10.2 Turbine Generator

The information in this section of the reference ABWR DCD, including all subsections, tables and figures, is incorporated by reference with the following departures and supplements.

Figure 10.2-1 Turbine Stop Valve Closure Characteristic

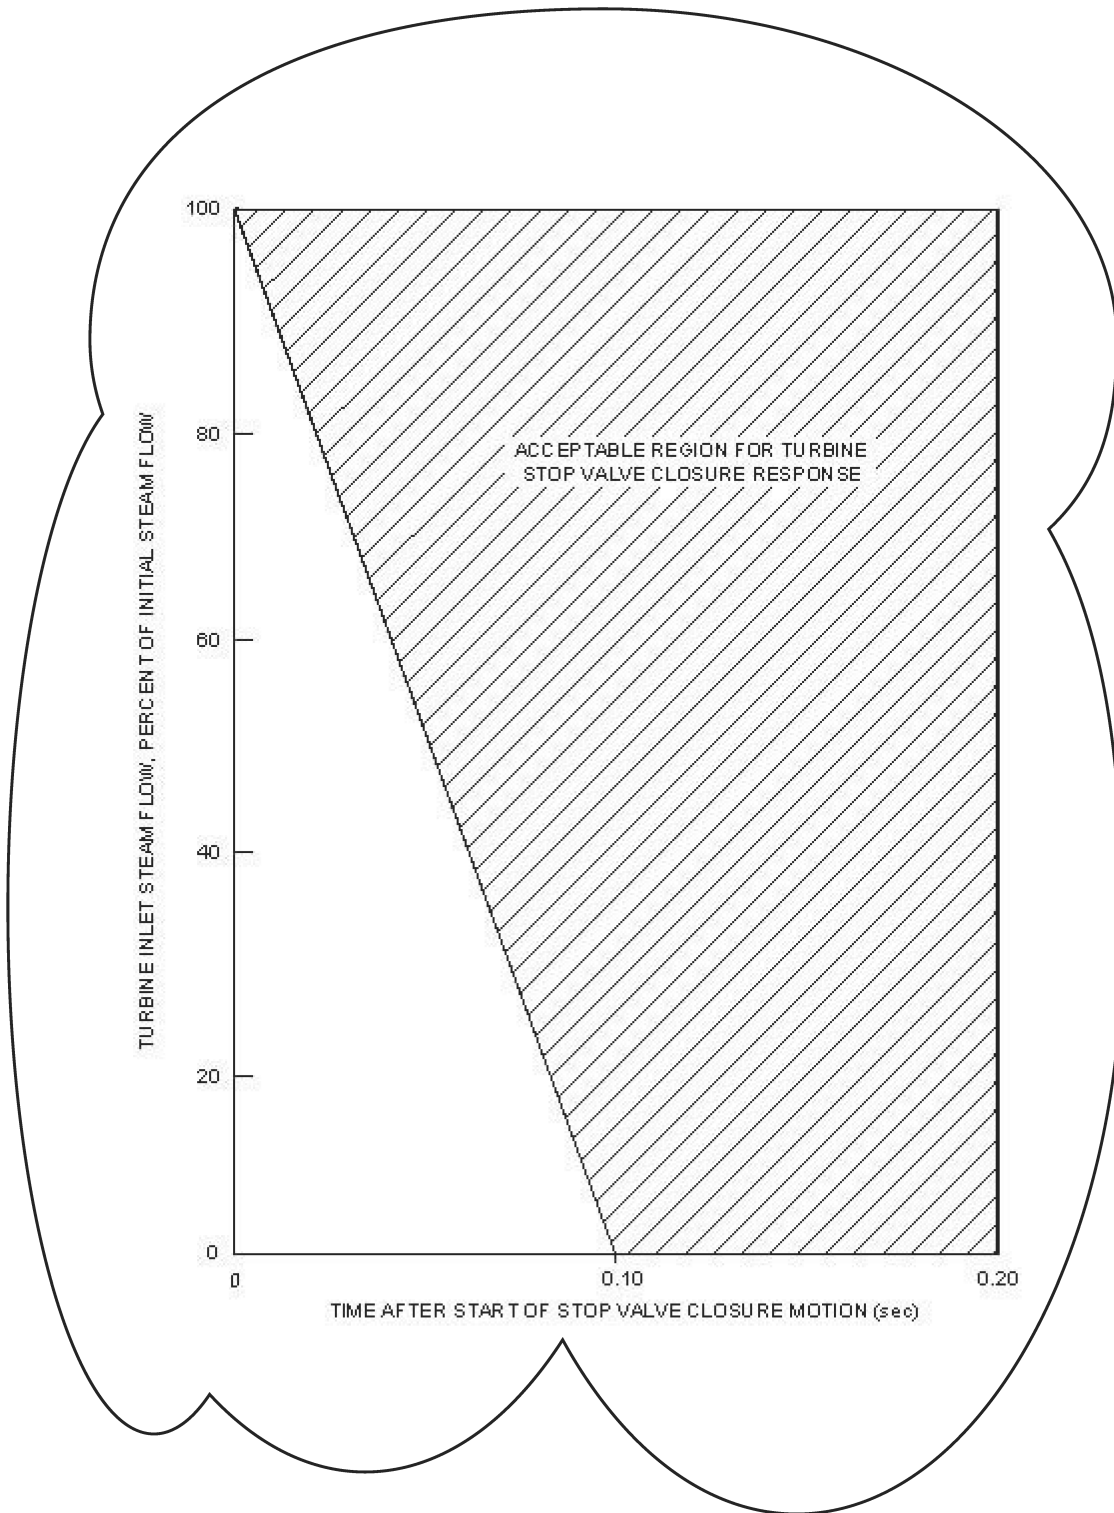
STD DEP Admin (Figure 10.2-1)

Figure 10.2-4 Generator Hydrogen and CO₂ System

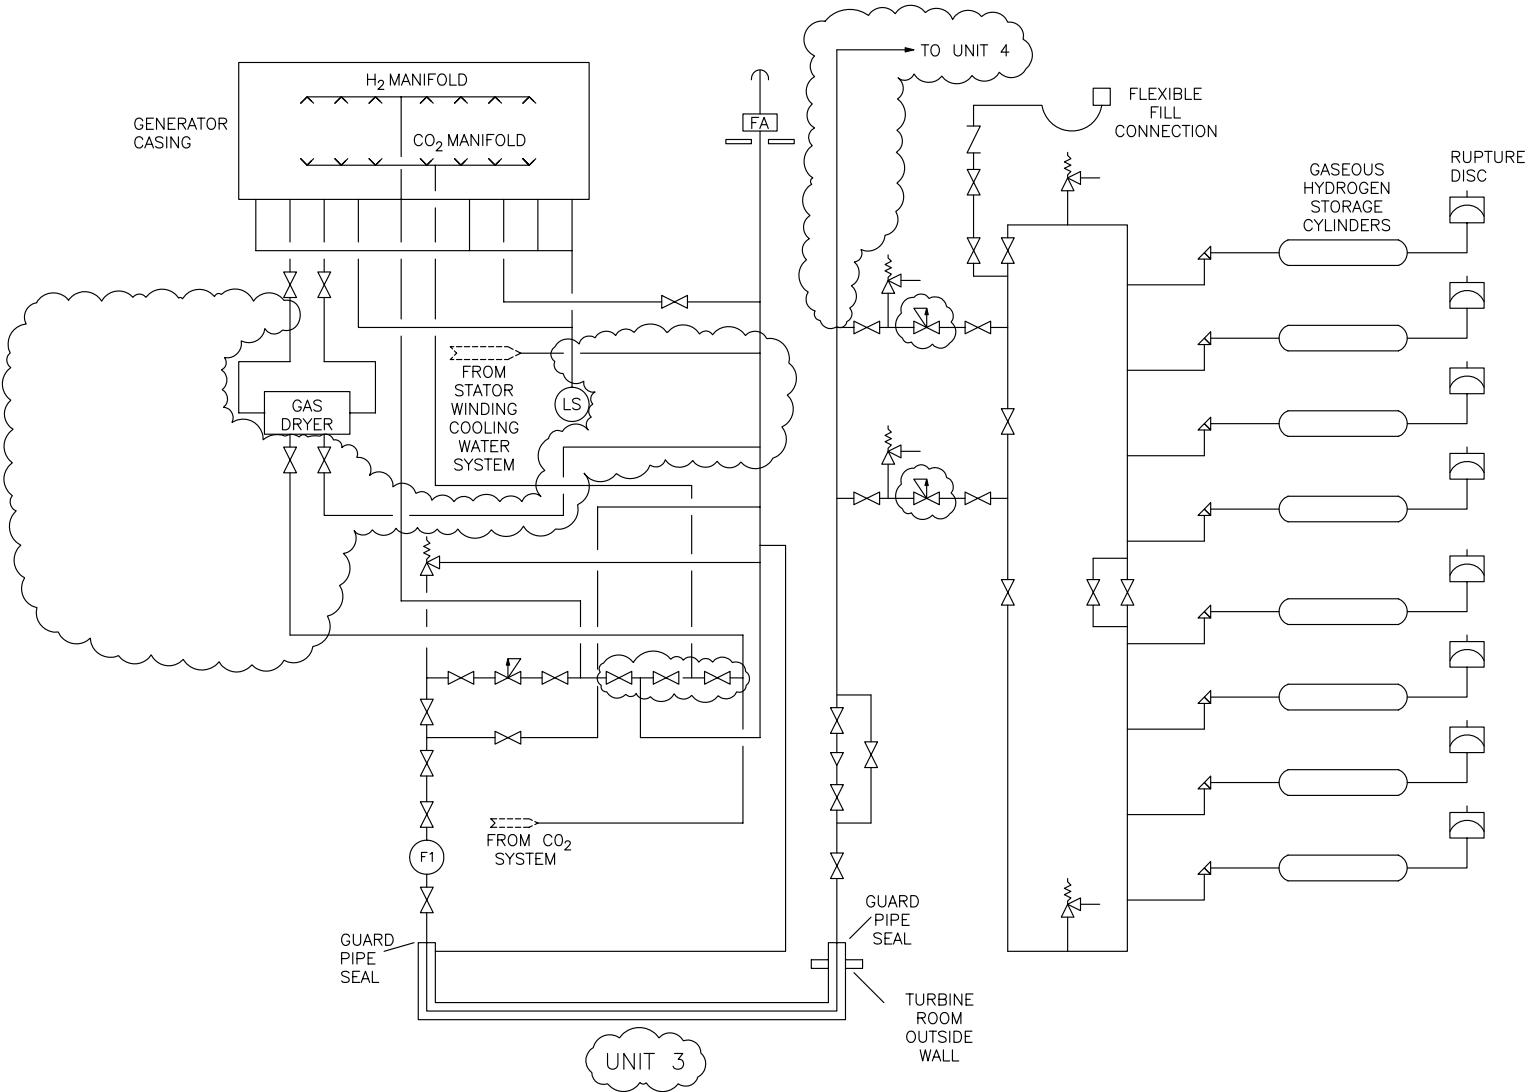
STP DEP 1.1-2 (Figure 10.2-4)

STP DEP 10.2-1 (Figure 10.2-4)

Bulk Hydrogen System—*The bulk hydrogen and CO₂ system is illustrated on Figure 10.2-4. The hydrogen system is designed to provide the necessary flow and pressure at the main generator for purging carbon dioxide during startup and supply makeup hydrogen for generator leakage during normal operation.*

Figure 10.2-5 Turbine Overspeed Trip System Functional Diagram

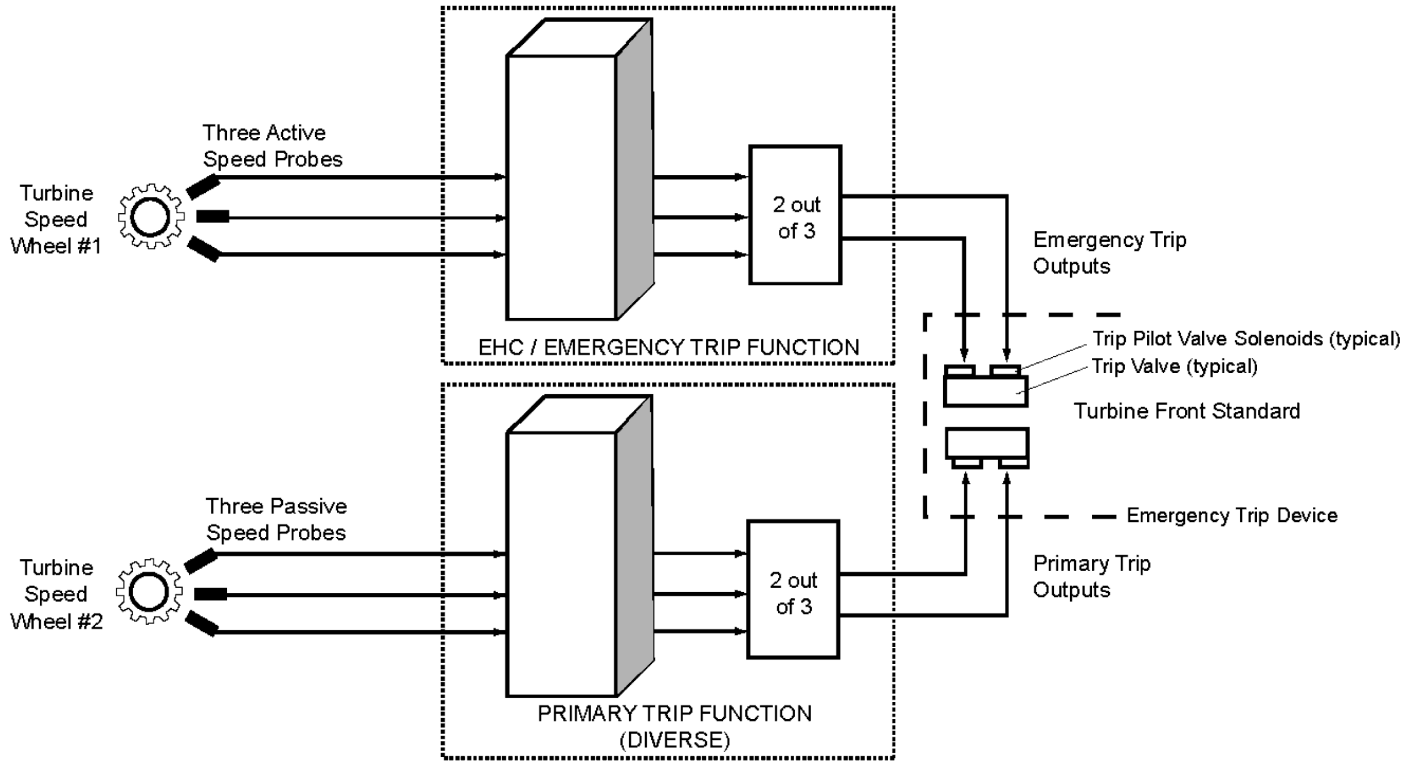
The primary trip function is independent and diverse from the emergency trip function as explained below (refer to Figure 10.2-5, Turbine Overspeed Trip System Functional Diagram). Two-out-of-three logic is employed in both the primary and emergency overspeed trip circuitry. Each trip function can de-energize its associated trip pilot valve solenoids of the electro-hydraulic Emergency Trip Device (ETD). The ETD is composed of two independent trip valves, each with two normally energized fail-safe solenoids. For each trip valve, each trip pilot valve solenoid is powered from a separate power source. The solenoids de-energize in response to detection of an overspeed condition by the turbine speed control logic. De-energization of both trip pilot valve solenoids is necessary to cause the spool in their respective trip valve to reposition, which depressurizes the emergency trip fluid system, rapidly closing all steam inlet valves and indirectly closing the steam extraction nonreturn valves. Accordingly, the repositioning of only one of the two trip valves is necessary to trip the main turbine. A single electrical component failure does not compromise trip protection, and does not result in a turbine trip. Each trip valve in the ETD is testable while the turbine is in operation.

and emergency overspeed trip functions also use separate speed wheels (refer to Figure 10.2-5). Each speed signal for the primary trip function is compared to a speed setpoint of approximately 110% of rated speed, and produces trip signals arranged in two-out-of-three logics, to de-energize both trip pilot valve solenoids of one of the two trip valves of the ETD. Both trip pilot valve solenoids must be de-energized to trip the associated trip valve. The ETD has two redundant trip valves. Tripping of either redundant trip valve will drain the emergency trip fluid, resulting in a turbine trip.
